Design Refinements

Refinement of Aldclune Junction Northbound Diverge Slip Road

Design Refinements

Design Refinements

Cross-section through refined design model at Category B Listed Wall within Urrard Estate.

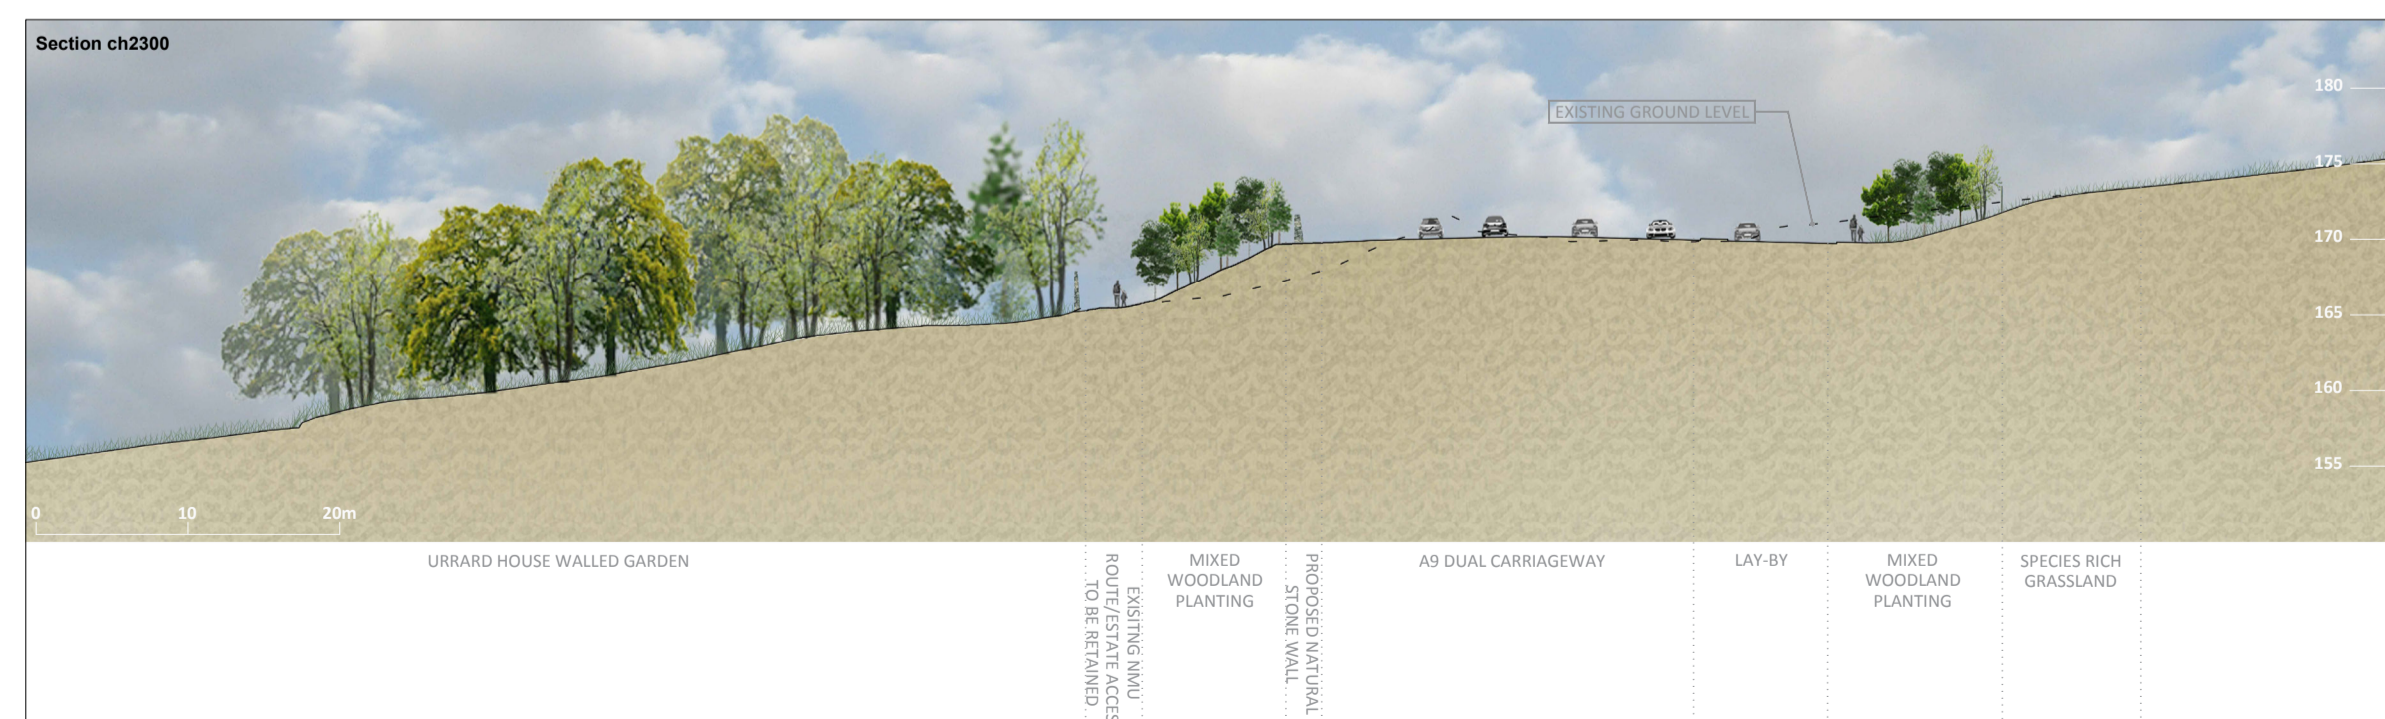
The verge cross-section of the previously published DMRB Stage 3 design includes a bund which was introduced to replace the existing bund located adjacent to the Urrard Walled Garden following feedback from public consultation.

A design that balances the footprint within the Killiecrankie Battlefield, landscape impacts and noise impacts on properties in Killiecrankie has been identified.

The refinement of the design replaces the proposed bund with two separate lengths of natural stone wall in the northbound verge.

By introducing the natural stone walls rather than a bund, this reduces land take within Fields F5, F6 and F7 of the Killiecrankie Battlefield.

The combined length of the two natural stone walls would be approximately 430m. The location of these natural stone walls is shown on Figure 2 and the previously published DMRB Stage 3 design is also shown on this figure for comparison purposes.
